CCO #42 Review Comments
By
Sandy Michelotti & Michael Travis
March 21, 2008

SAS SUPERSTRUCTURE ROADWAY WESTBOUND
LIGHTING AND ELECTRICAL SYSTEMS

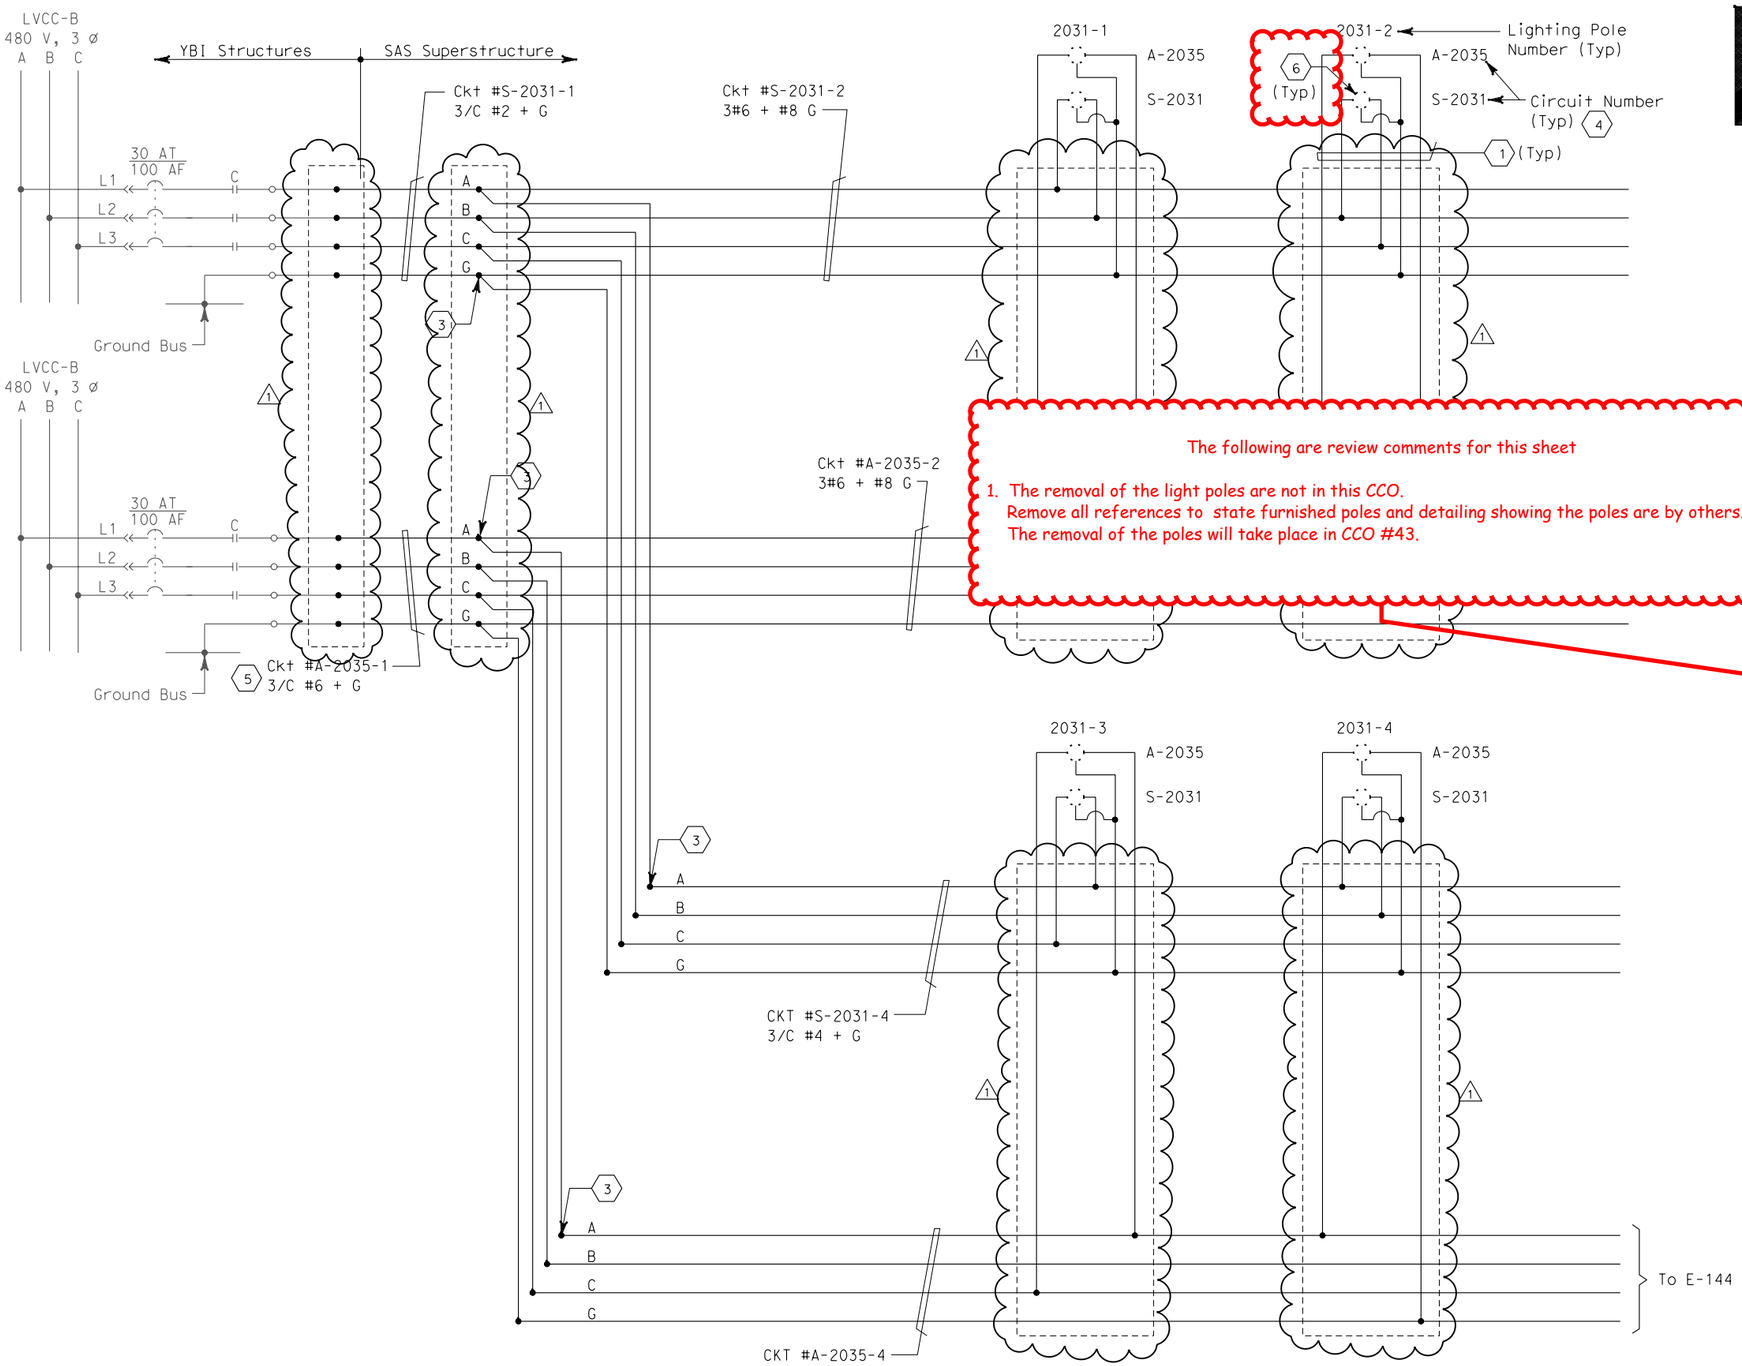
1. The removal of the light poles are not in this CCO.
Remove all references to state furnished poles and detailing showing the poles are by others.
The removal of the poles will take place in CCO #43.

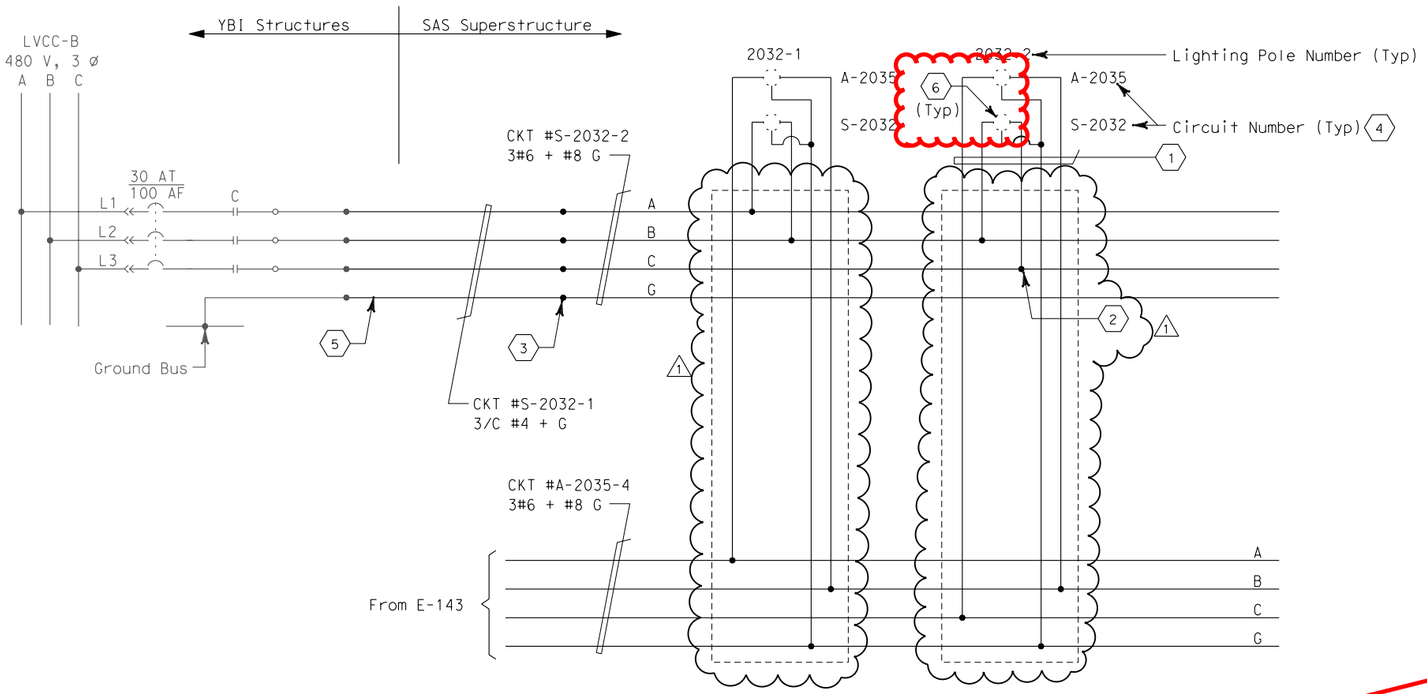
1. The removal of the light poles are not in this CCO.
   Remove all references to state furnished poles and detailing showing the poles are by others.
   The removal of the poles will take place in CCO #43.

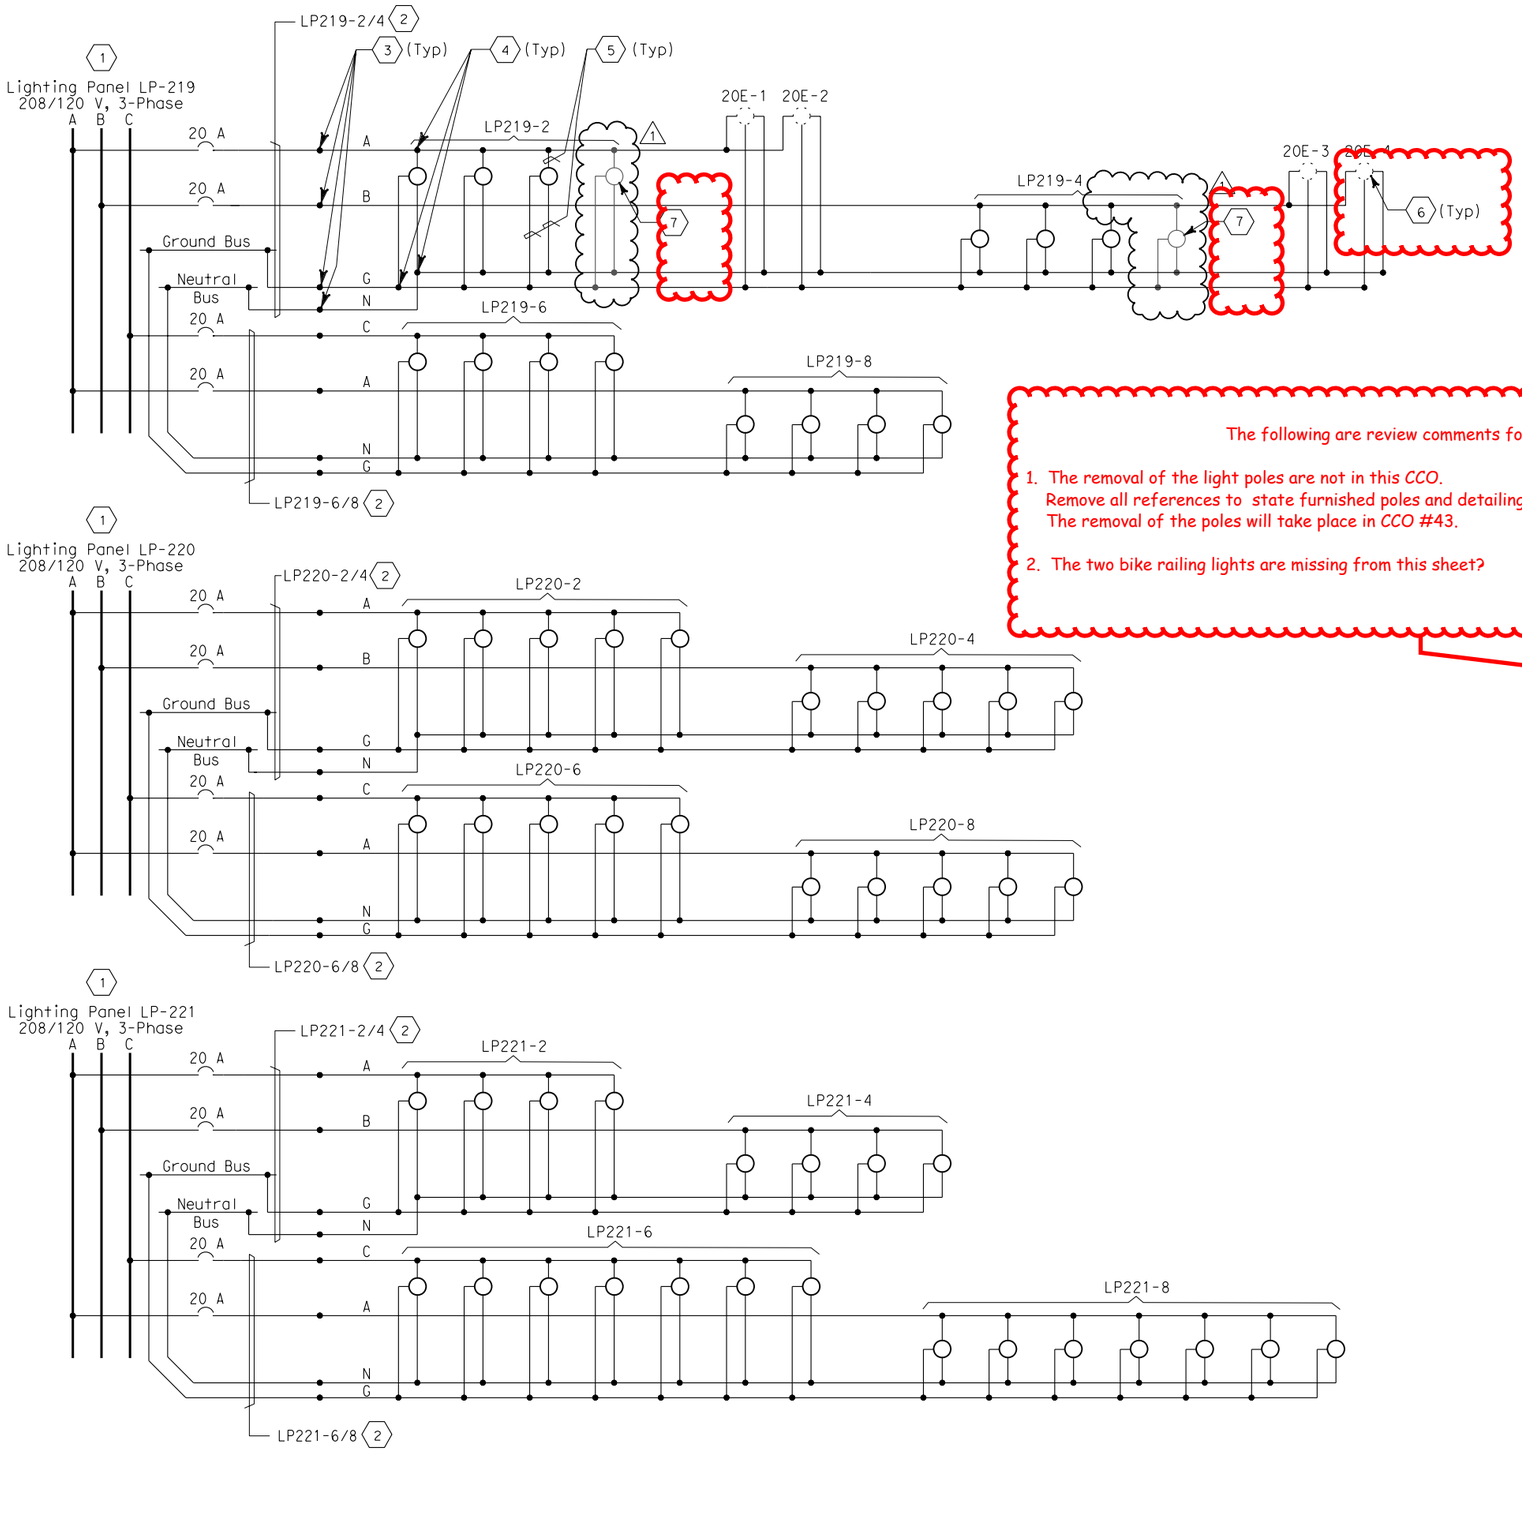
1. The removal of the light poles are not in this CCO.
   Remove all references to state furnished poles and detailing showing the poles are by others.
   The removal of the poles will take place in CCO #43.

2. The two bike railing lights are missing from this sheet?

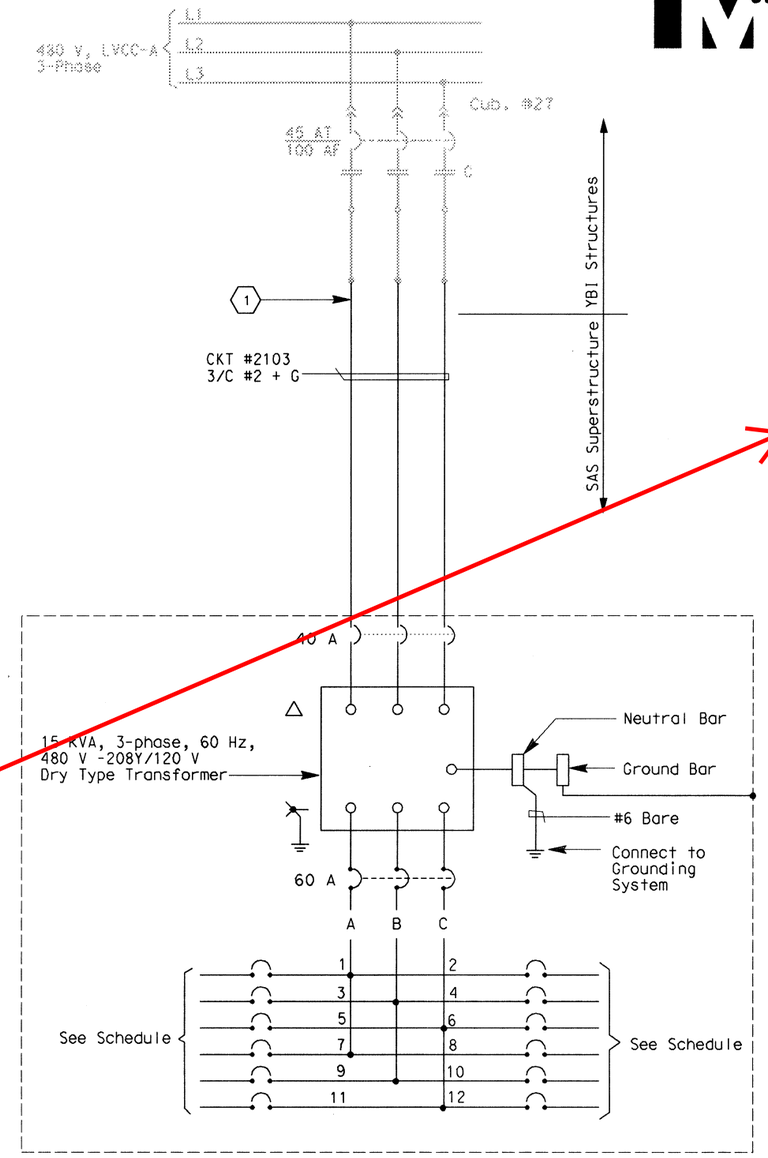
1. This sheet was missing from the last updated CCO # 42 Set.
There are still items that are associated with this CCO included in this sheet.

TYPICAL UPLIGHT CONDUIT LAYOUT
SCALE 1:20

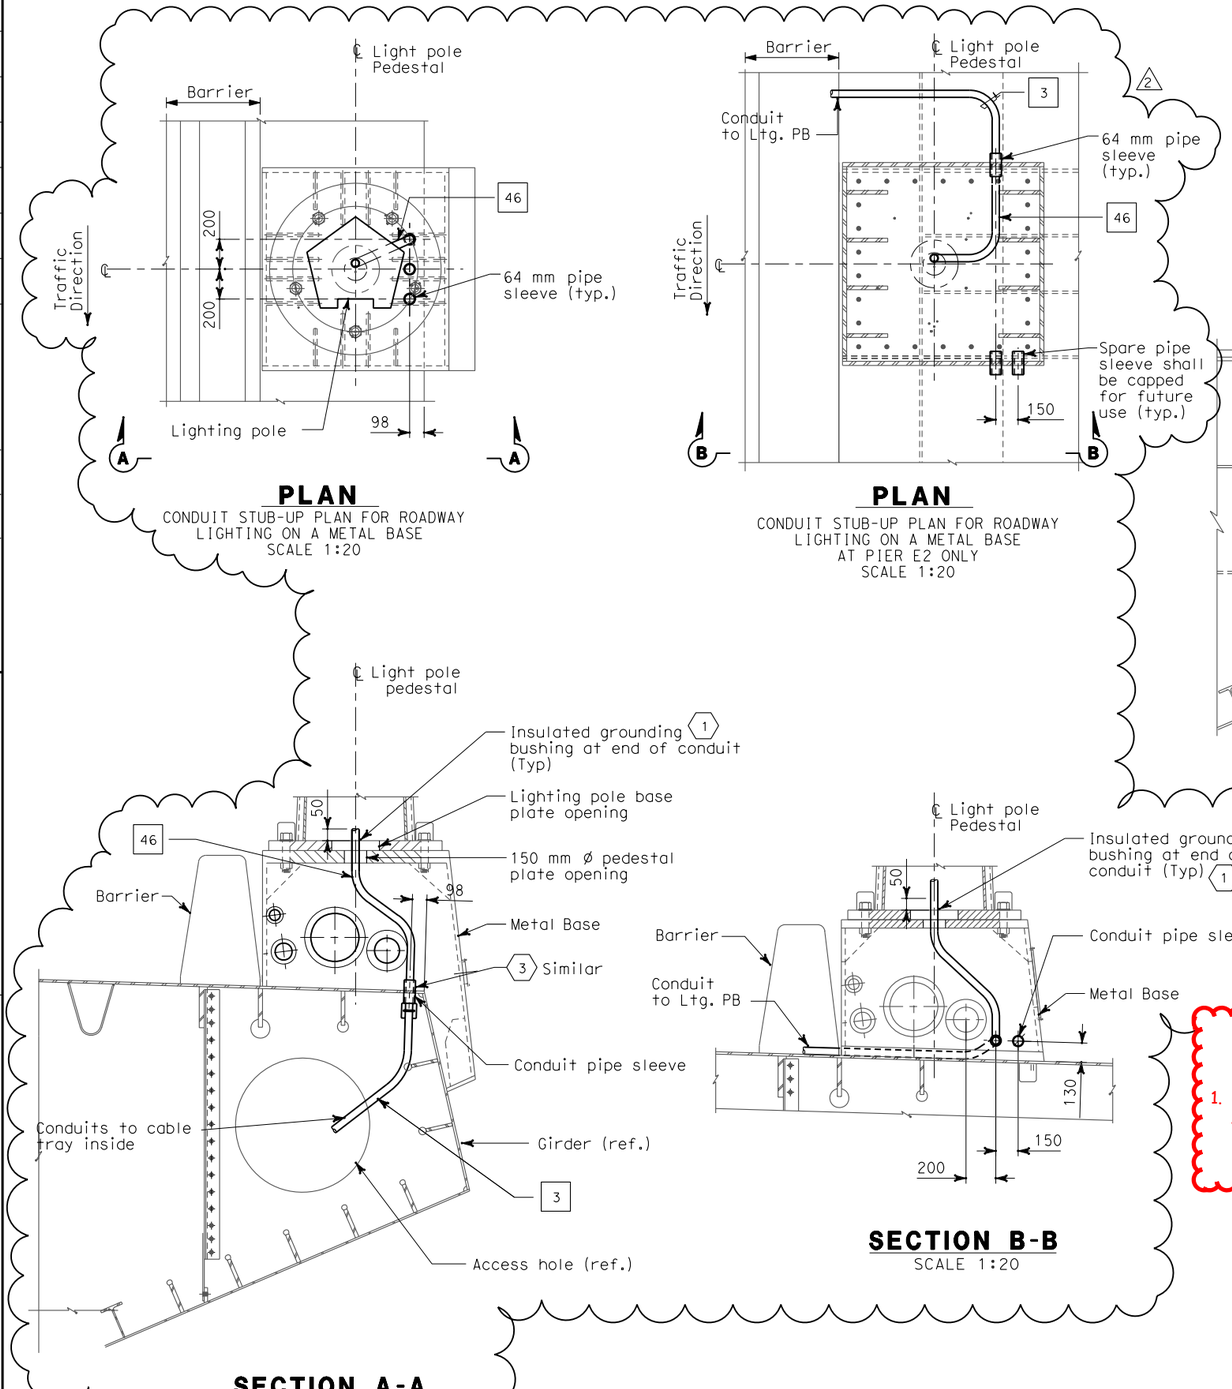
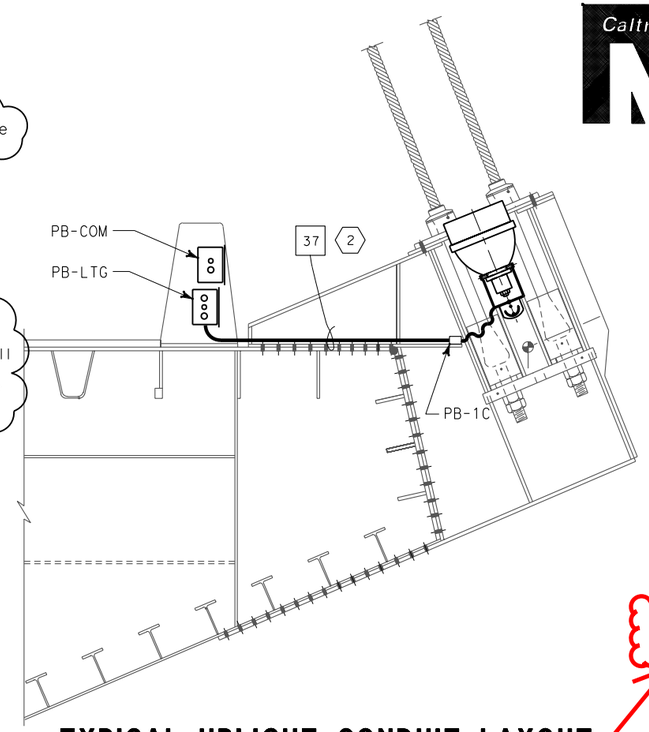
1. Marks from previous CCO's are to be removed when a new CCO modifies the sheet. See CCO guidelines.
